CITY PLAN COMMISSION STAFF REPORT

Kinsley Multi-Family Phase II

CD-CPC-2024-00033

Development Plan – Residential (major amendment)

NOVO KINSLEY
NEW CONSTRUCTION DEVELOPMENT

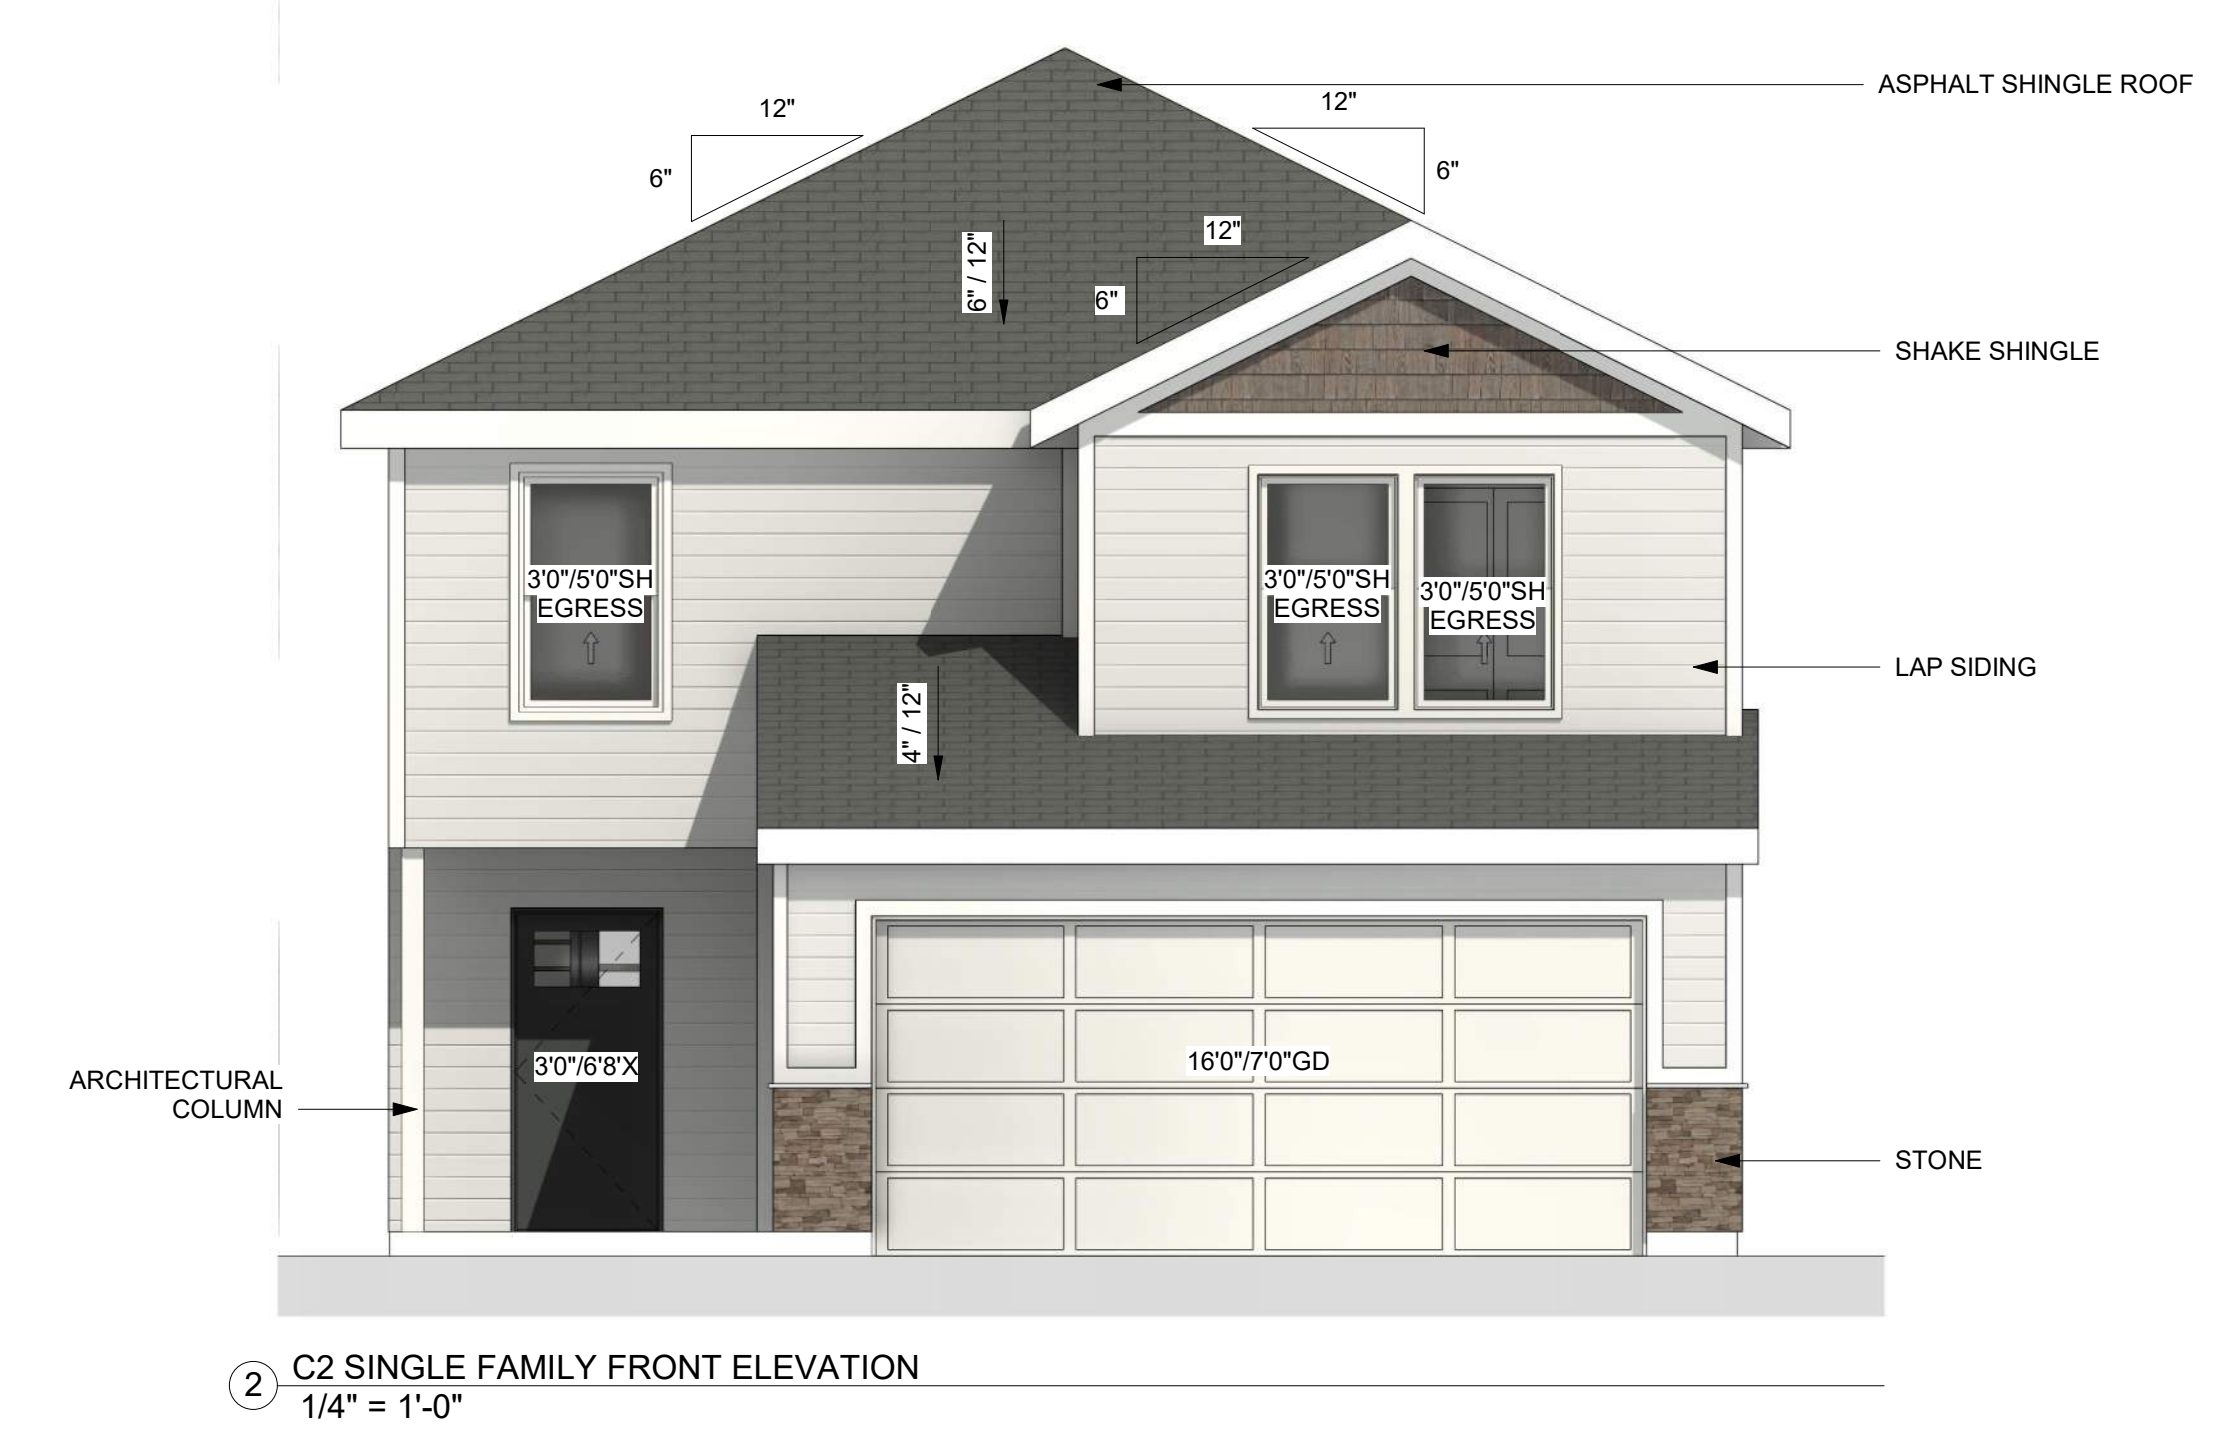
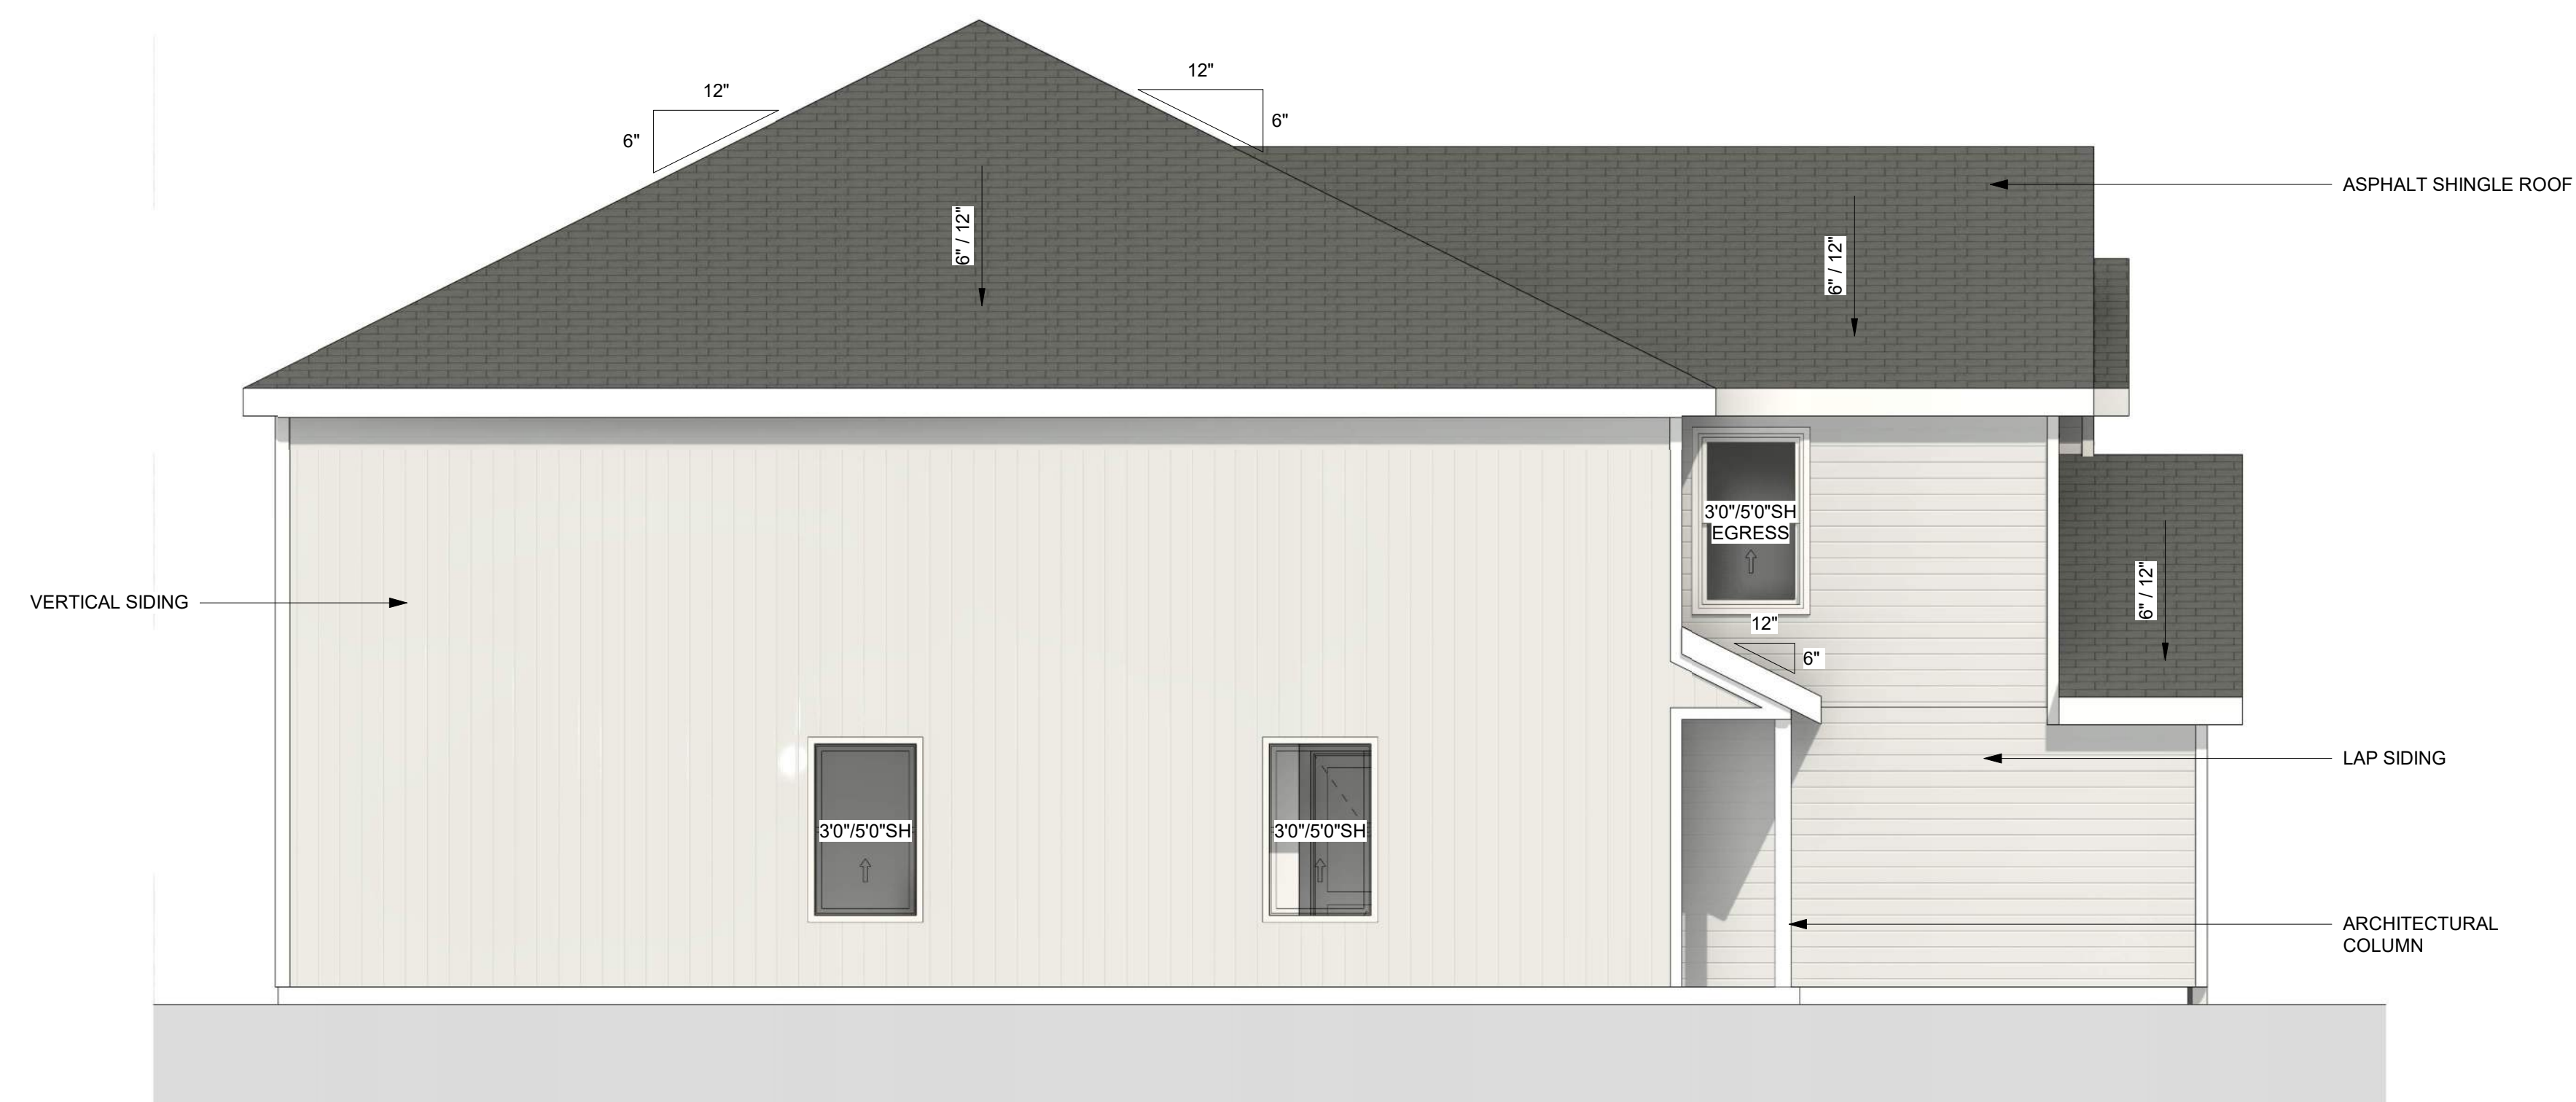
32. The developer shall include the same stone masonry shown on the front elevations of the residential buildings for the quadplex facades front facing the Boulevard.
